# SERVICE BULLETIN

COMMUNICATIONS  
75S-3B RECEIVER, CPN 522-3316-000  
75S-3C RECEIVER, CPN 522-3317-000  
SERVICE BULLETIN NO. 2

## SECOND MIXER PLATE CIRCUIT IMPROVEMENT

Chassis Component Location, Bottom View Figure 1

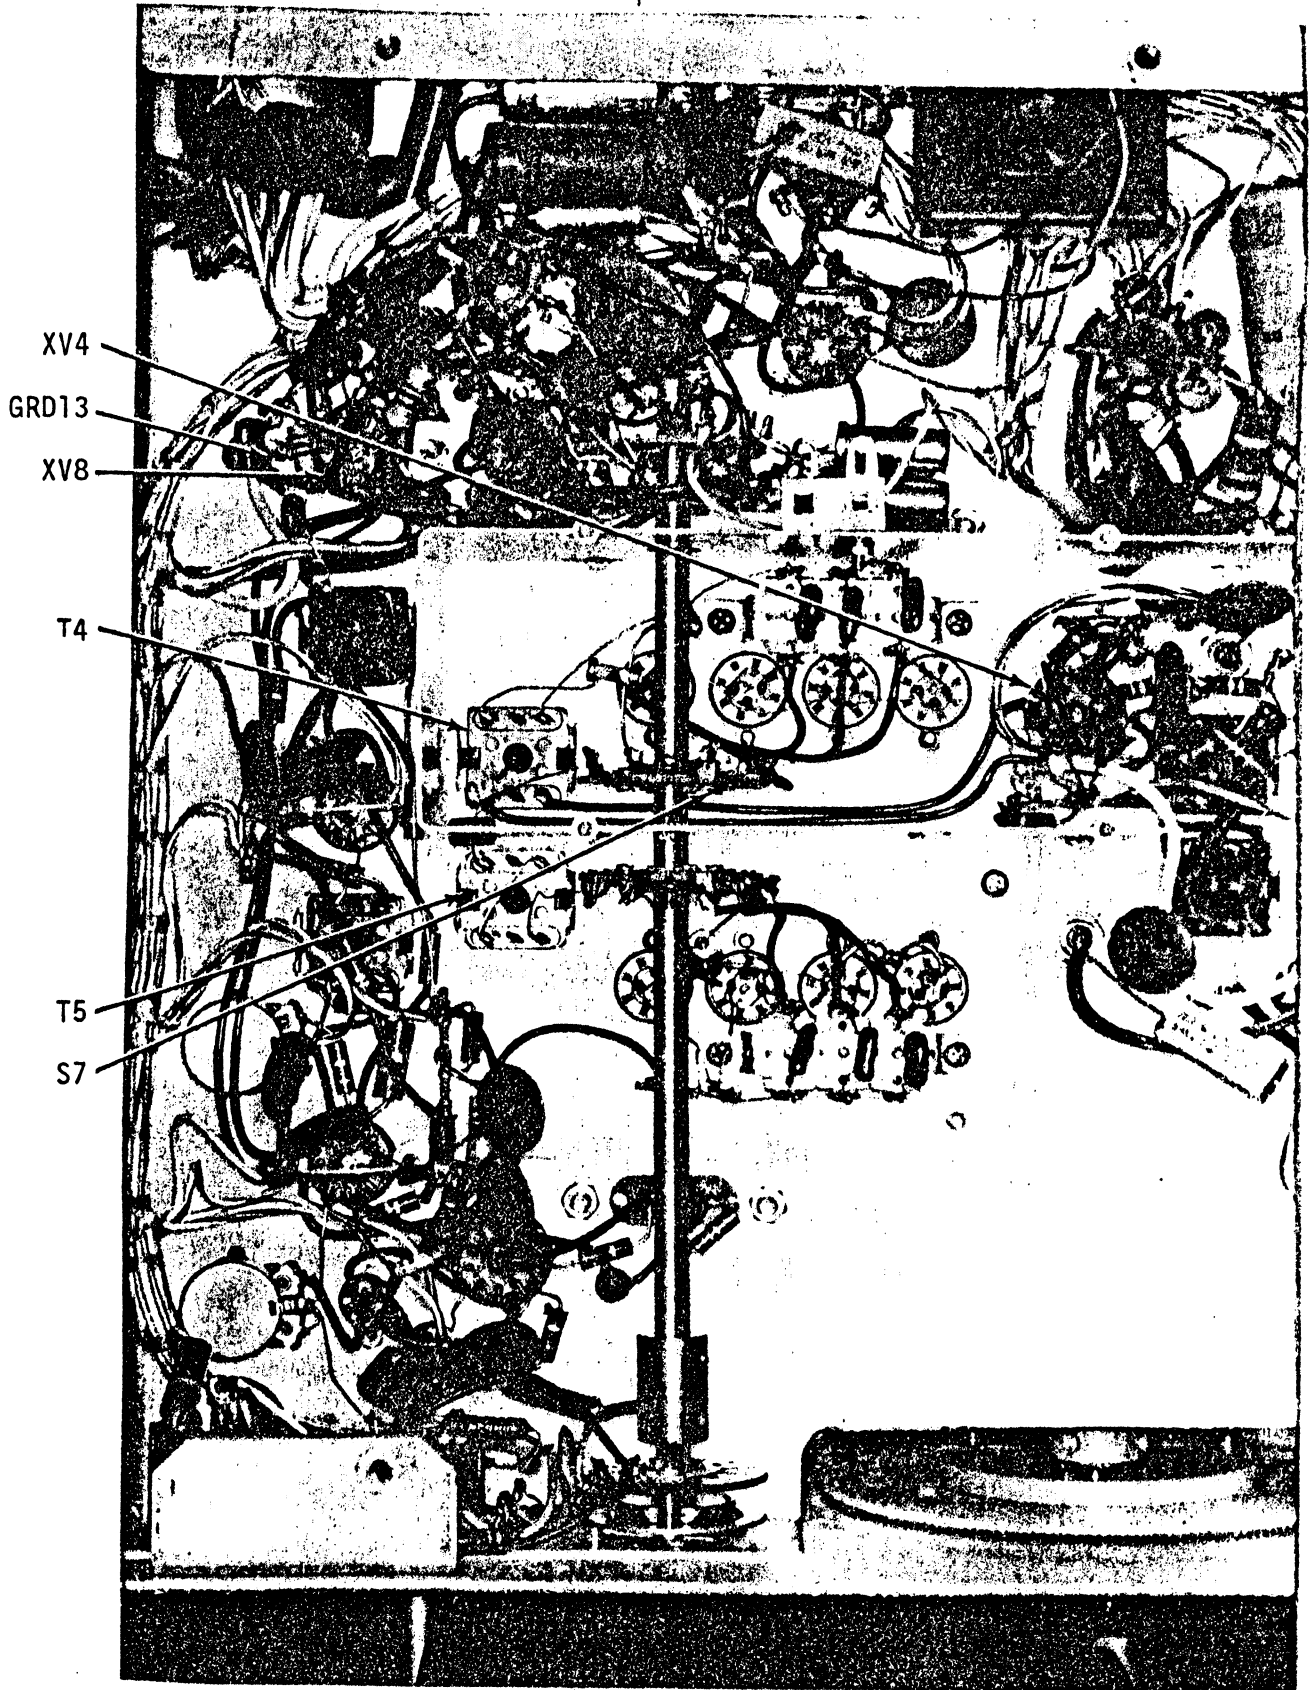
- (1) Remove four feet and the screw located midway between rear feet from bottom of cabinet.
(2) Remove the unpainted screws located under lid along front of cabinet.
(3) Slide chassis from the cabinet.
(4) Referring to figure 1 for location, remove cover over T4 and XV4. Retain cover and attaching hardware.
(5) Referring to figure 1 for locations, remove and discard the following components and wires from their respective connections:

Table with 3 columns: DESCRIPTION, FROM, TO. Rows include: 15K resistor, R89 (S7-10 to Ground); 0.001-uf capacitor, C32 (S7-10 to XV4-6); 3-pf capacitor, C92 (T4-3 to T5-3); 10-mh choke, L4 (XV4-1 to XV4-6); 100-uh choke, L16 (XV8-8 to Ground); Bus wire (T4-4 to T4-2); Bus wire (T4-1 to S7-5).

Chassis Component Location, Bottom View  
Figure 2

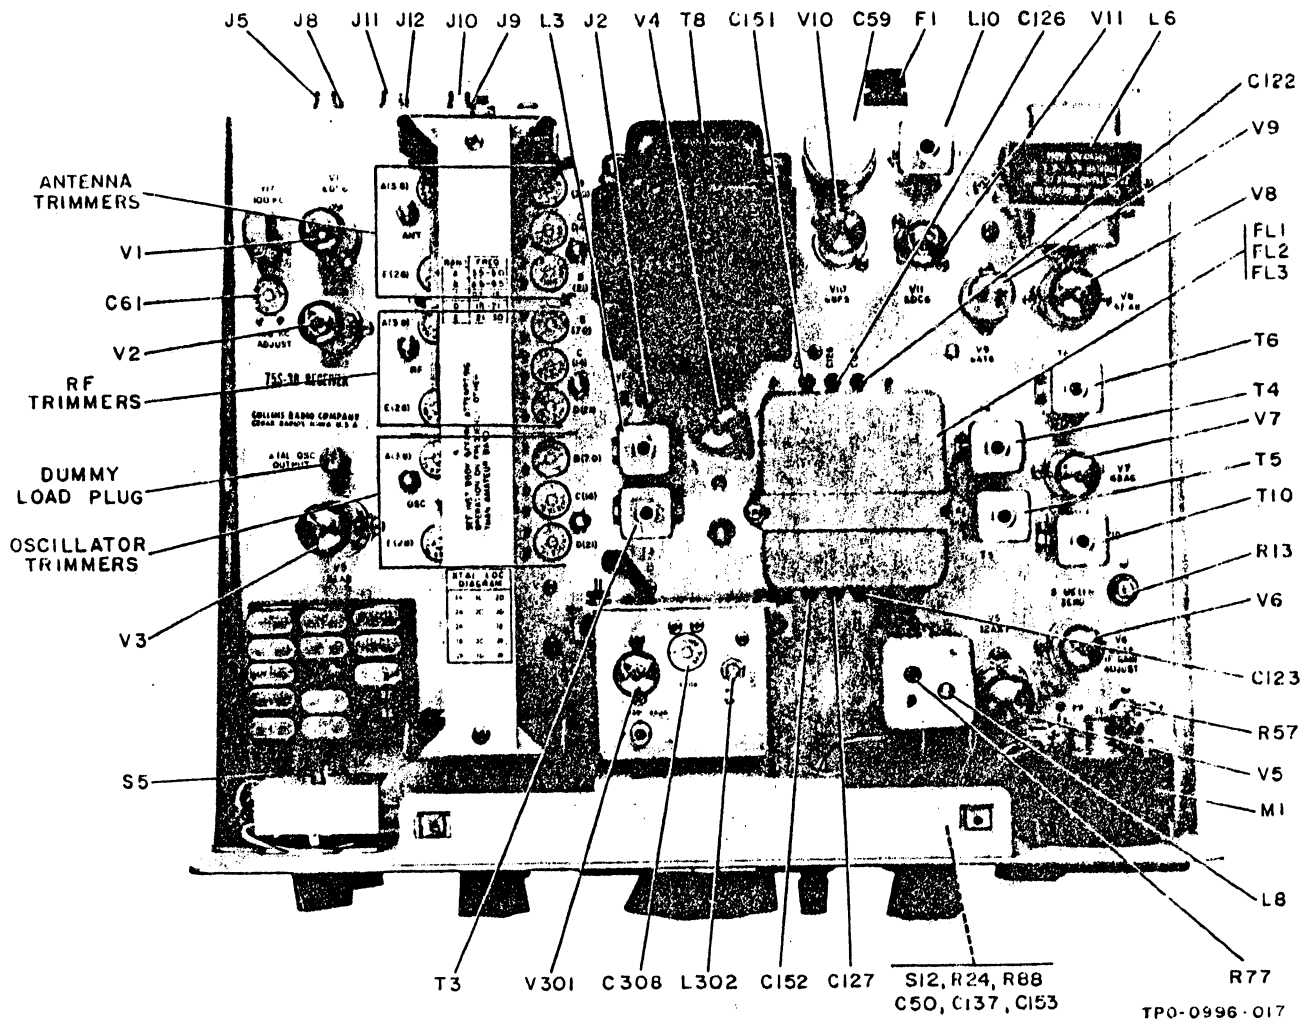
- (6) Referring to figure 2 for locations, install the following components and wires to their respective connections:

Table with 4 columns: COLLINS PART NO., DESCRIPTION, FROM, TO. Rows include: 422-4312-000 Wire, #22 AWG bus, Teflon (XV4-3 to T4-2); 422-4312-000 Wire, #22 AWG bus, Teflon (XV4-6 to T4-1); 916-0122-000 6-pf capacitor, C92 (T5-3 to S7-5); 916-0122-000 6-pf capacitor, C32 (T4-3 to S7-10 (common)); 240-2141-000 100-uh choke, L16 (XV8-8 to Ground).

75S-3B/3C Location of Adjustments  
Figure 3

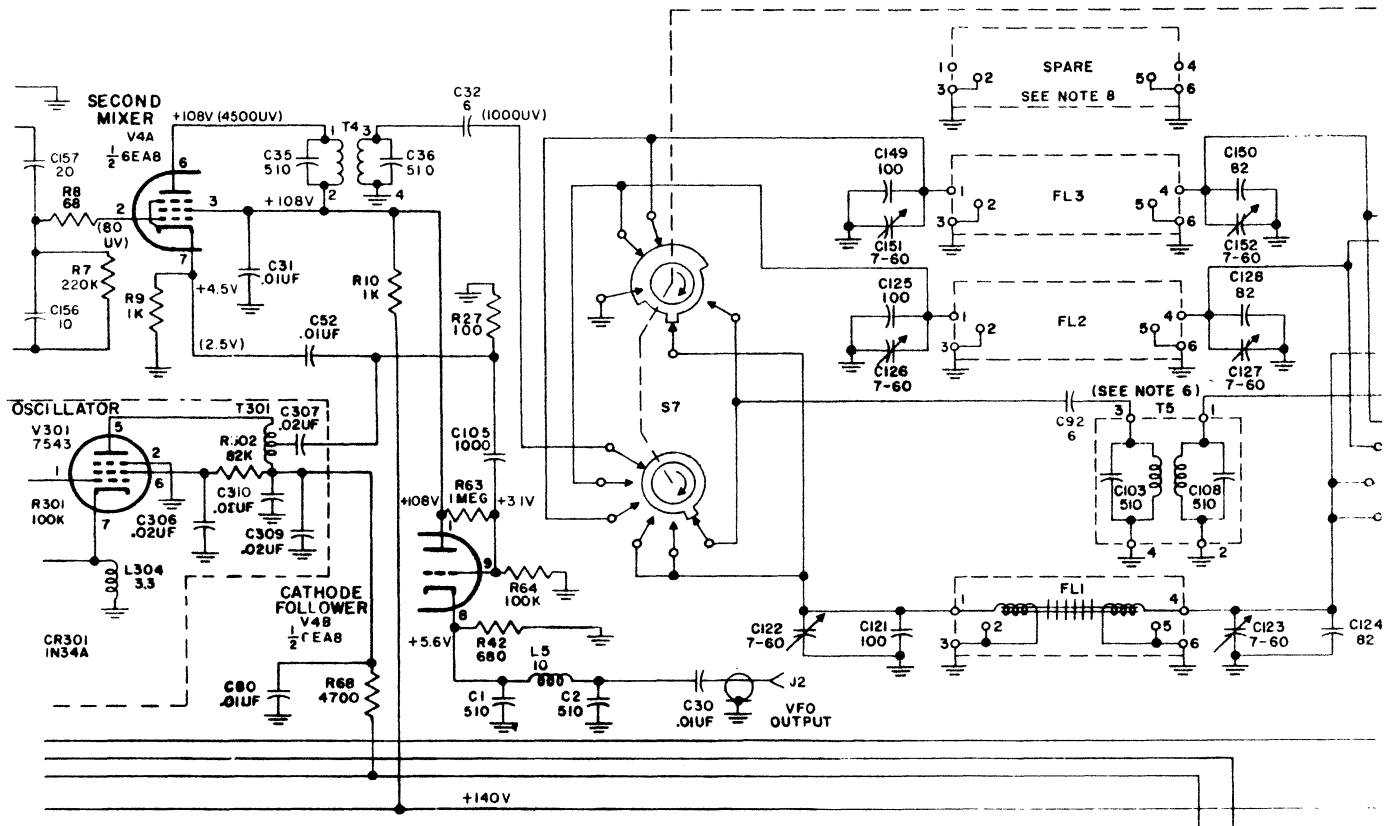
- (1) Referring to figure 3 for tuning adjustment locations, perform the following alignment steps using the crystal calibrator as a signal source and the S-meter as a peak indicator:

- (a) Position MODE switch to LSB and FUNCTION switch to CAL. Tune receiver to center of bandpass near 100 on the dial (approximately 1.5 kHz tone) and adjust PRESELECTOR for an S-5 reading on the S-meter.
  - (b) Using Walsco 2543 hex-tuning wrench or equivalent, peak the two slugs in T4. Both slugs can be peaked from the top of the unit.
  - (c) Peak capacitor C122 with a small flat-blade screwdriver.
  - (d) Repeat peaking T4 slugs.
- (2) Replace cover removed in step (4), and replace chassis to cabinet removed in paragraph 2.A. step (1).
